## V2500-A5/D5 SERIES PROPULSION SYSTEMS SERVICE BULLETIN

# V2500-ENG-72-0538

ENGINE – HIGH PRESSURE (HP) COMPRESSOR –VARIABLE INLET GUIDE VANES (VIGV) AND  
VARIABLE STAGE VANES (VSV) ACTUATING MECHANISM – INTRODUCTION OF SIMPLIFIED CONTROL  
RODS

VIGV and VSV control rods  
Figure 1 (Sheet 1 of 3)

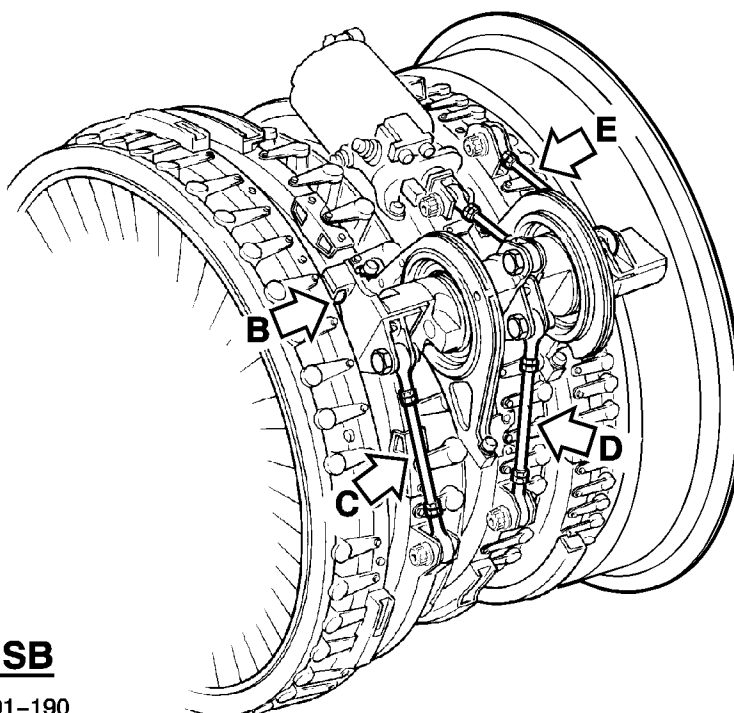
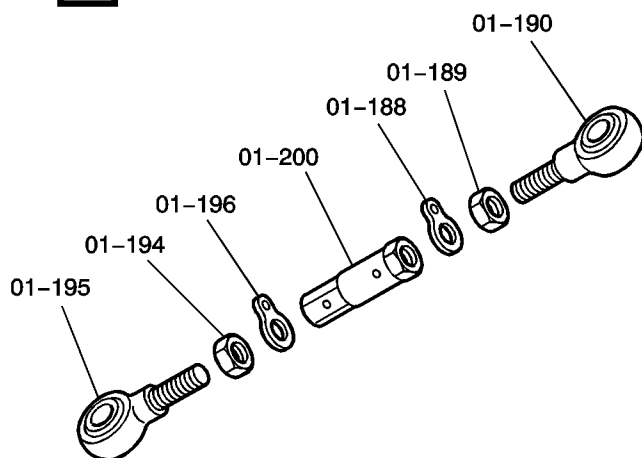
The current design of the High Pressure (HP) compressor variable inlet guide vane (VIGV) control rod and the HP compressor variable stage vane (VSV) actuator, stages 3, 4 and 5 control rods is different.

The design of the VIGV control rod only uses male control rod end bearings, which are threaded into the control rods. One end of the control rod has a left hand thread and a left hand threaded control rod end bearing. Only the VIGV control rod assembly uses locking washers.

This Service Bulletin introduces a new design of VIGV/VSV control rod assembly to replace the current installed VIGV/VSV control rod assembly, except the VSV control rod for the actuator. The new design keeps the same key dimensions i.e. overall length and width with similar adjustment compared to the current standard. The dimensions of the VSV control rod end bearings are the same as the current design, making them compatible with the existing unison rings and crankshaft designs.

- (b) Disassemble the VIGV control rod assembly
    - (i) Remove the two locking washers (72-41-34, 01-188) and (72-41-34, 01-196), the two old nuts (72-41-34, 01-189), P/N A234-6LW and (72-41-34, 01-194), P/N A234-5RW, the old RH rod end bearing (72-41-34, 01-195), P/N 01-412-05E025 and the old control rod (72-41-34, 01-200), P/N 6A4519.

- (ii) Install the two locking washers (72-41-34, 01-188) and (72-41-34, 01-196), the two new nuts (72-41-34, 01-189), P/N NAS509L6C and (72-41-34, 01-194), P/N NAS509-5C and the new RH rod end bearing (72-41-34, 01-195), P/N 01-412-05E037 to the new control rod (72-41-34, 01-200), P/N 6A8647.

VIGV and VSV control rods  
Figure 1 (Sheet 2 of 3)

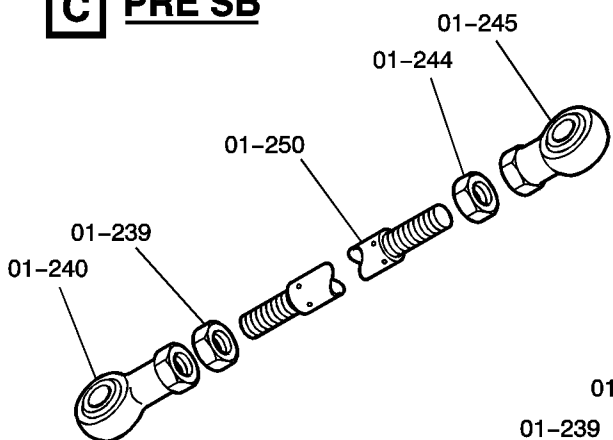
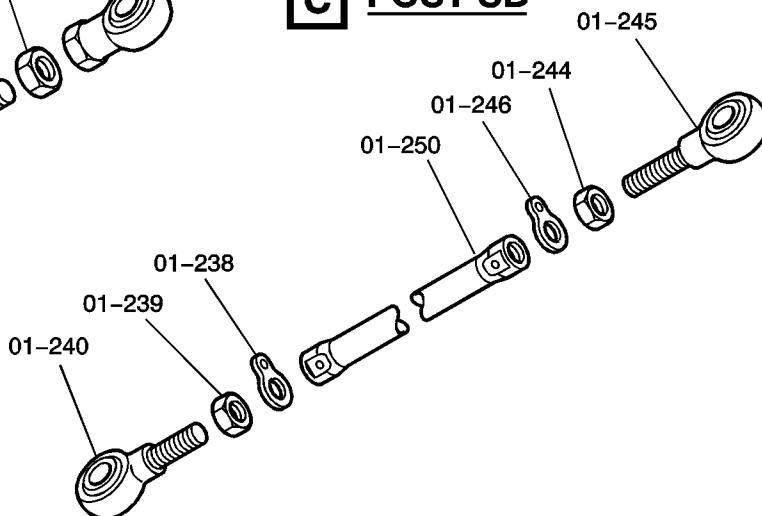
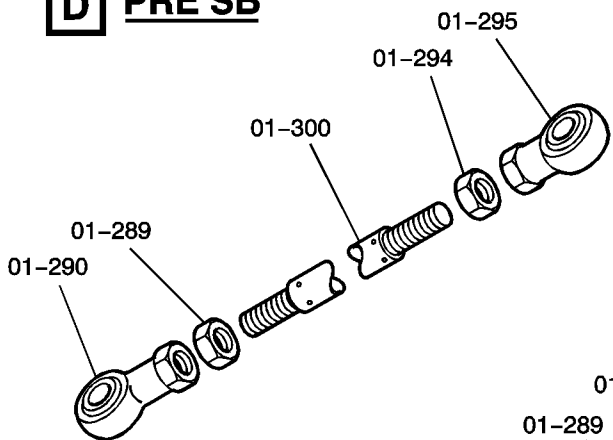
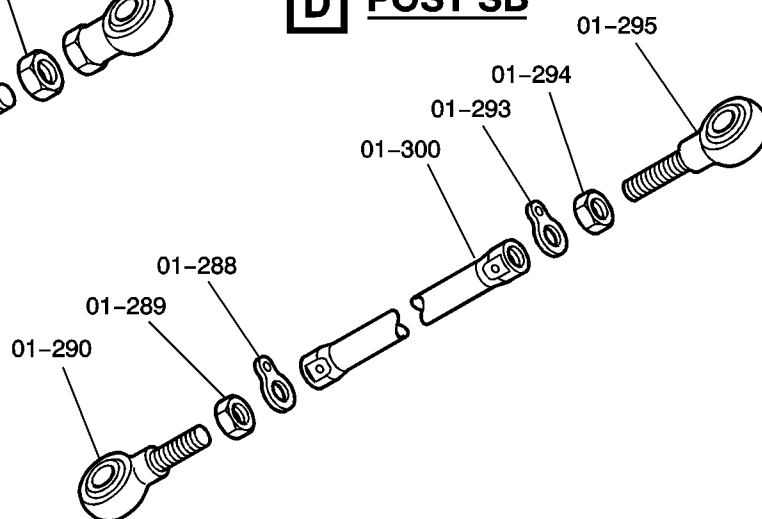
The design of the VSV actuator and stages 3, 4 and 5 control rods only uses female control rod end bearings, which are threaded onto the control rods. One end of the control rod has left hand thread and a left hand threaded control rod end bearing. The control rod end bearings are locked to the VSV control rods by lock nuts and secured by locking wire.

The new VSV control rods for stages 3, 4 and 5 have female threads. The control rod for the VIGV already has female threads. The bearings in the new VIGV/VSV control rod ends are unchanged making them compatible with the existing unison rings and crankshaft designs.

The thread of the VSV control rod end bearings has changed from female to male for stages 3, 4 and 5, as this commonises the control rod end bearings. The VIGV control rod end bearings already have male threads. The VSV control rod end bearing thread diameters are reduced from 0.375" to 0.3125" on stages 3, 4 and 5. The diameter of the VIGV rod and the thread pitch and form remain unchanged.

- (i) Remove the two old nuts (72-41-34, 01-239), P/NA234-6LW and (72-41-34, 01-244), P/N A234-6RW, the old LH rod end bearing (72-41-34, 01-240), P/N 12-412-05E002, the old RH rod end bearing (72-41-34, 01-245), P/N 02-412-05E002 and the old control rod (72-41-34, 01-250), P/N 6A2564.

- (ii) Install the new LH rod end bearing (72-41-34, 01-240), P/N 11-412-05E037, the new nut (72-41-34, 01-239), P/N NAS509L5C, the new locking washer (72-41-34, 01-238), P/N 6A4579 and the new RH rod end bearing (72-41-34, 01-245), P/N 01-412-05E037, the new nut (72-41-34, 01-244), P/N NAS509-5C, the new locking washer (72-41-34, 01-246), P/N 6A4579 to the new control rod (72-41-34, 01-250), P/N 6A8691.

- (b) Remove the old stage 4 control rod assembly
- (i) Remove the two old nuts (72-41-34, 01-289), P/N A234-6LW and (72-41-34, 01-294), P/N A234-6RW, the old LH rod end bearing (72-41-34, 01-290), P/N 12-412-05E002, the old RH rod end bearing (72-41-34, 01-295), P/N 02-412-05E002 and the old control rod (72-41-34, 01-300), P/N 6A4515.

- (ii) Install the new LH rod end bearing (72-41-34, 01-290), P/N 11-412-05E037, the new nut (72-41-34, 01-289), P/N NAS509L5C, the new locking washer (72-41-34, 01-288), P/N 6A4579 and the new RH rod end bearing (72-41-34, 01-295), P/N 01-412-05E037, the new nut (72-41-34, 01-294), P/N NAS509-5C, the new locking washer (72-41-34, 01-293), P/N 6A4579 to the new control rod (72-41-34, 01-300), P/N 6A8690.

Adjustment of the control rods  
Figure 2

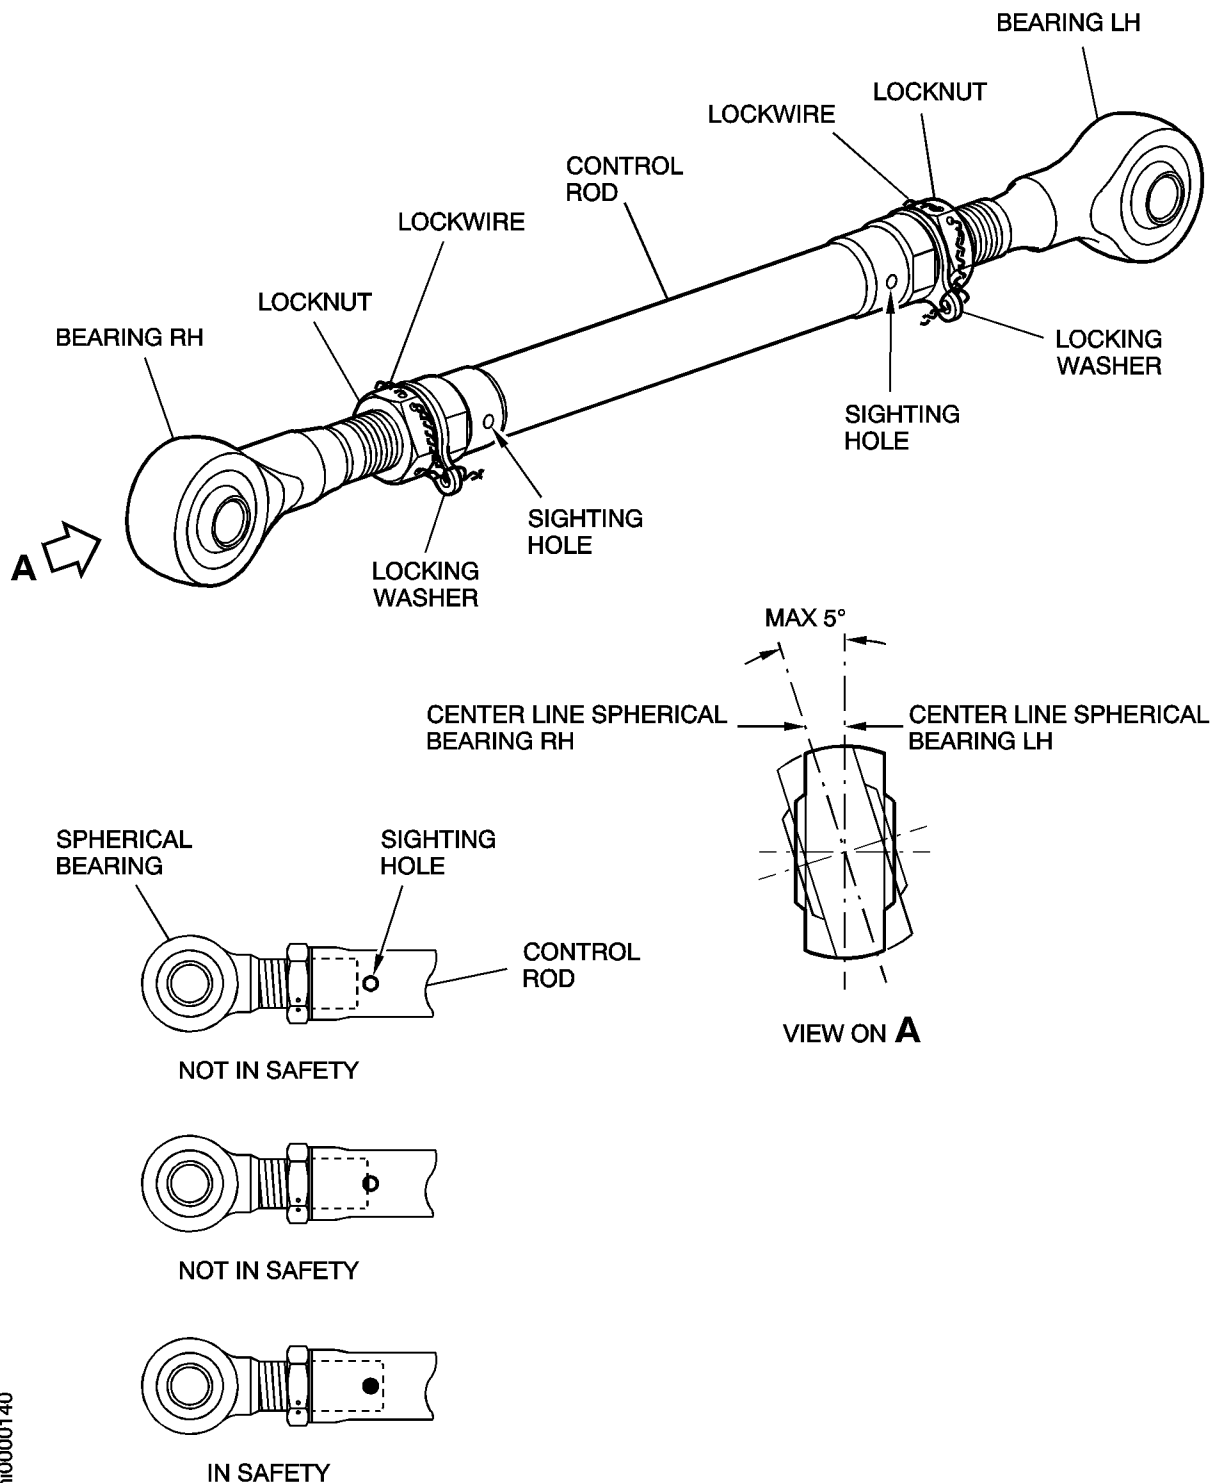
- (i) If necessary, adjust the stage 3 control rod assembly (Refer to Figure 2)
      - (1) Remove the locking wire from the stage 3 control rod assembly.

- (2) Release the two locknuts (72-41-34, 01-239) and (72-41-34, 01-244).
- NOTE:** The locknut (72-41-34, 01-239) has left hand thread.
- (3) Turn the center part of the control rod (72-41-34, 01-250), to adjust the length of the control rod assembly, until the bolt can be easily installed.

- (4) With the bolt installed examine the sighting holes to make sure that the control rod is in safety.
  - (5) Torque the two locknuts (72-41-34, 01-239) and (72-41-34, 01-244) to between 180 and 220 lbf in. (20 and 25 Nm).

- (6) Make sure that the control rod end bearings (72-41-34, 01-240) and (72-41-34, 01-245) are aligned to less than 5 degrees.
  - (7) Safety the locknut (72-41-34, 01-239) with the locking washer (72-41-34, 01-238) and the locknut (72-41-34, 01-244) with the locking washer (72-41-34, 01-246) to the control rod (72-41-34, 01-250) with lockwire (Material No. V02-126).
